SUBJECT: ARKANSAS NUCLEAR ONE, UNIT 2 - ISSUANCE OF AMENDMENT NO. 325
RE: REVISE LOSS OF VOLTAGE RELAY ALLOWABLE VALUES AND
NUMBER OF DEGRADED VOLTAGE CHANNELS (EPID L-2020-LLA-0193)

SAFETY EVALUATION BY THE OFFICE OF NUCLEAR REACTOR REGULATION

RELATED TO AMENDMENT NO. 325 TO

ARKANSAS NUCLEAR ONE, UNIT 2

Figure 1: Licensee's Summary of the Calibration of the LOV Relay

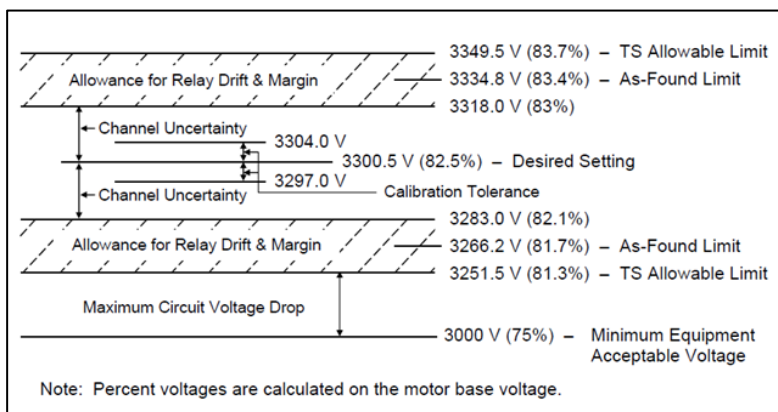
In the LAR, the licensee provided a figure, as illustrated in Figure 1 below, as a high-level summary of the various calibration components.

Using the licensee's equations and information in Figure 1 above, the NRC staff summarized the following results of the licensee's calculations in Table 1 below:

Based on the information in Table 1 and Figure 1 above, the NRC staff used the guidance in RG 1.105, Revision 3, to independently confirm whether there are adequate margins for instrument channel performance uncertainty between the AL and V_{DRD} or NTS (Margin_{NTS}) and associated AV (Margin_{AV}) (for Functional Unit 7.a in ANO-2 TS Table 3.3-4 of Section 3.3.2.1) to satisfy the requirements of 10 CFR 50.36(c)(1)(ii)(A). It should be noted that the NRC staff performed an evaluation of the Margin_{NTS} and Margin_{AV} of the lower level only because the

Based on the information in Table 1 and Figures 1 and 2 above, the NRC staff has determined the following with respect to the proposed AV for the LOV Relay in ANO-2 TS 3.3.2.1, specifically Functional Unit 7.a in TS Table 3.3-4:

Based on the above discussion, the NRC staff finds that the proposed LOV relay settings (maximum and minimum AVs) for Functional Unit 7.a in Table 3.3-4 of TS Section 3.3.2.1 are consistent with RG 1.105, Revision 3, satisfy the requirements of 10 CFR 50.36(c)(1)(ii)(A), and continue to meet GDC 13. Therefore, the proposed AVs (3300.5 ± 49 V) are acceptable.

Figure 2: LOV Relay AVs and NTS (or V_{DRD}) Relationships and Margins Calculated by the NRC Staff

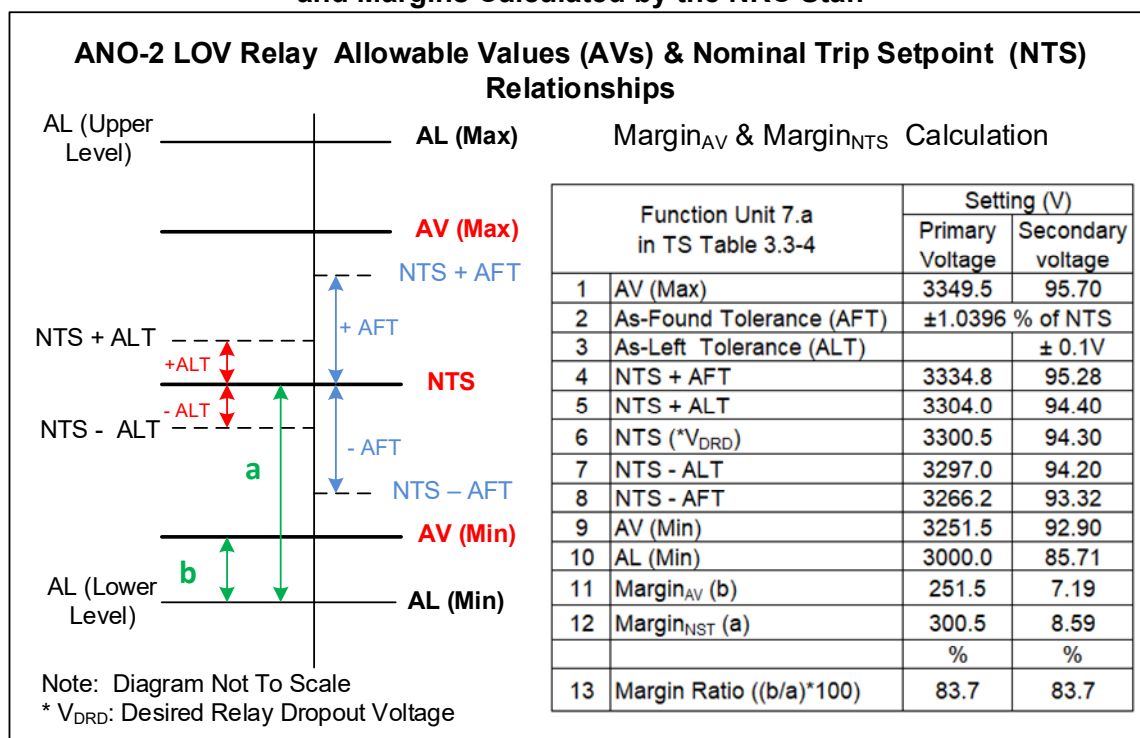
In this confirmatory evaluation, the NRC staff considered the minimum equipment acceptable voltage (3000 V) as the AL of the lower level. The NRC staff's evaluation and confirmatory results are summarized in Figure 2 below:

- The NTS, inclusive of their AFTs, are less than the maximum AV and greater than the minimum AV, and therefore, would assure that the trip signals will be initiated before the NTS reached the AV values.
- The margin ratio percentage between the NTS and AV margins is greater than 83 percent and is adequate. These margins ensure that the trip setpoints have been chosen to assure that a trip or safety actuation will occur significantly before the measured process reaches the lower ALs (minimum equipment acceptable voltage). The proposed AV setting supports an automatic protective action that will correct the abnormal situation before a safety limit is exceeded.

- The proposed maximum and minimum TS AVs of the LOV relay are higher than the minimum allowable motor terminal momentary voltage of 75 percent of the motor voltage rating of 4000 V to ensure that 4160 V and 480 V motors will not stall if already running, and to maintain these variables and systems within prescribed operating ranges.

Figure 3: LOV Relay Time Delay Settings Relationships and Margins Calculation by the NRC Staff

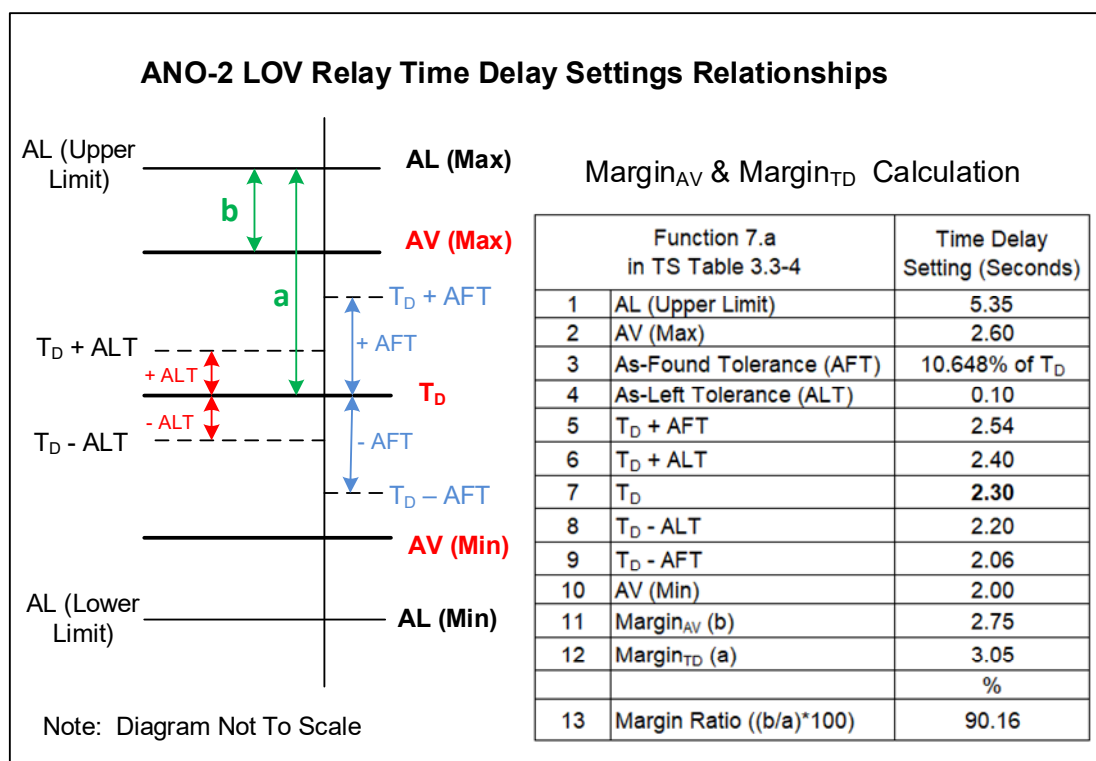
The NRC staff's evaluation is summarized in Figure 3 below.

Based on the information in Table 2 and Figure 3 above, the NRC staff has determined the following with respect to the proposed AV for the LOV relay time delay associated with Functional Unit 7.a in Table 3.3-4 of Section 3.3.3.2.1 of ANO-2 TS:

- The T_D , inclusive of the AFTs (\pm AFTs), ($T_D + \text{AFT}$) is less than the maximum AV, and ($T_D - \text{AFT}$) is greater than the minimum AV, and therefore, would ensure that the trip signals will be initiated before the T_D reaches the AV values.

- The margin ratio percentage between the T_D and AV margin is greater than 90 percent and is adequate. This margin ensures that the trip setpoint has been chosen to assure that a trip or safety actuation will occur significantly before the measured process reaches the Upper ALs. The proposed AV setting supports an automatic protective action that will correct the abnormal situation before a safety limit is exceeded.

- The proposed maximum/minimum TS AV is within the time delay setting range of 2 to 20 seconds of the ABB vendor manual for Type 27N undervoltage relays, Model 411T5175-HF-L, and would maintain the associated variables and systems within prescribed operating ranges.

Based on the above discussion, the NRC staff finds that the proposed AVs of the LOV time delay settings (maximum and minimum AV time delay) for SR 3.3.8.2.b (SR for the channel calibration performance) were developed consistent with the guidance in RG 1.105, satisfy the requirements of 10 CFR 50.36(c)(1)(ii)(A), and continue to meet GDC 13. Therefore, the proposed AVs for the relay time delay settings (≤ 2.6 seconds and ≥ 2.0 seconds) are acceptable.
